Dear reviewer,

MAJOR COMMENTS:

Dynamic inflow effects in measurements and high fidelity computations

Figure 1. Scaled axial force measurements from the Phase VI experiment at 5 m/s. The pitch steps are deloading the rotor (induction factor from $a=0.5$ to $a=0.0$, left plot) and loading the rotor ($a=0.0$ to $a=0.5$, right plot).

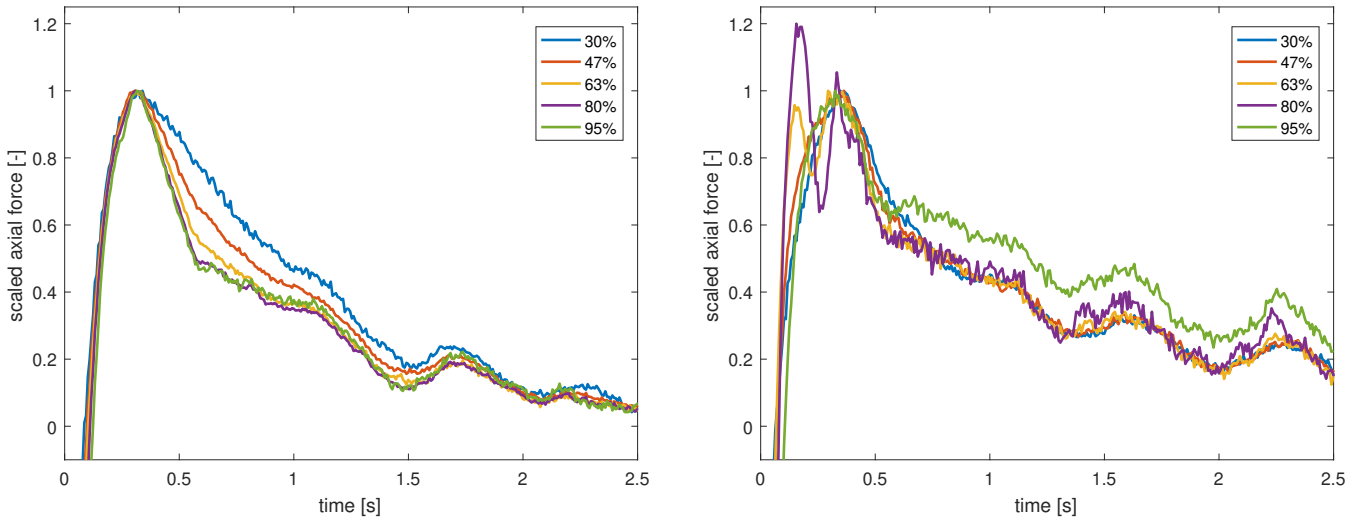
2- Page 2, line 28: the load fluctuations are not only to be seen at the 80% station but also, to a lower extent, at the 63% radial station.

3- Page 2, last paragraph. Please state when the pitching step was finished.

On line 26 of pg2, “The force is scaled such that. . .” I think it would be helpful to the reader to know more explicitly how this scaling of the force was done. I would suggest either labeling the ordinate axis in Figure 1 with this scaling (rather than just “scaled axial force”) or including it as an equation in the text.

- This is correct, and we state it in the revised article.

- At roughly 0.35 seconds in the plot where the maximum force overshoots are observed (except at the 80% station). This is stated in the revised article.

- This Equation has been added (now Equation (1)).

Figure 2. Sketch of cylindrical wake with radius R and a step change in vortex strength at a distance x from the rotor.

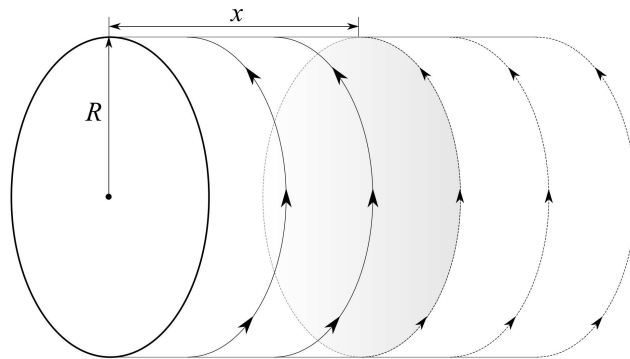
1- Is the vortex wake model the same as the one applied by Schepers (2007)? Is it a different implementation? What is new or different in your model?

- The following clarification has been added in the last paragraph before section 3.1:

Previously this model was used to analytically derive the time constant for a step change in circulation at the rotor disc, which is transported downstream with the free stream velocity. In the present work, the position of the step change is varied and the wake velocity v_w , see Equation (4), is chosen as the downstream convection velocity. Equation (5) is integrated numerically.

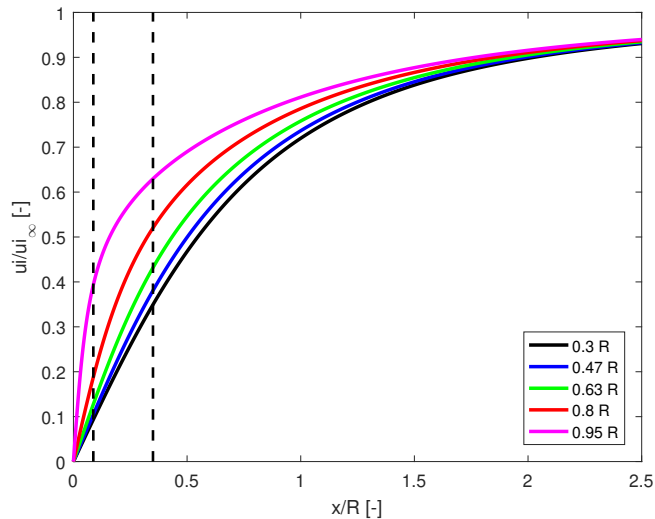
4- Page 3, line 8: how realistic is to neglect 2D unsteady airfoil effects? Do you expect this assumption to have an impact on the reliability of your results?

- at 0.35 seconds, the value of the most inboard section has reached roughly 90% of the final value, the most outboard section 99%. This is much faster than the dynamic inflow effect (see Figure 3 in the article). There is no strong influence of the induction because the time constants depend on the local relative speeds, which are dominated by the relative speed due to rotor rotation. Therefore they don't add any more asymmetry between the loading and deloading of the rotor.

The following has been included in the article: *2D unsteady airfoil aerodynamics and dynamic stall are neglected. To justify this, the force response to a step change in angle of attack has been computed using Jones' equations for a flat plate and the relative speeds at the disc. After 0.35 seconds (corresponding roughly to the pitch step duration), the force response reaches between 90% (most inboard section) and 99% (tip section) of its quasi steady value, showing that this effect is much faster than the dynamic inflow effect.*
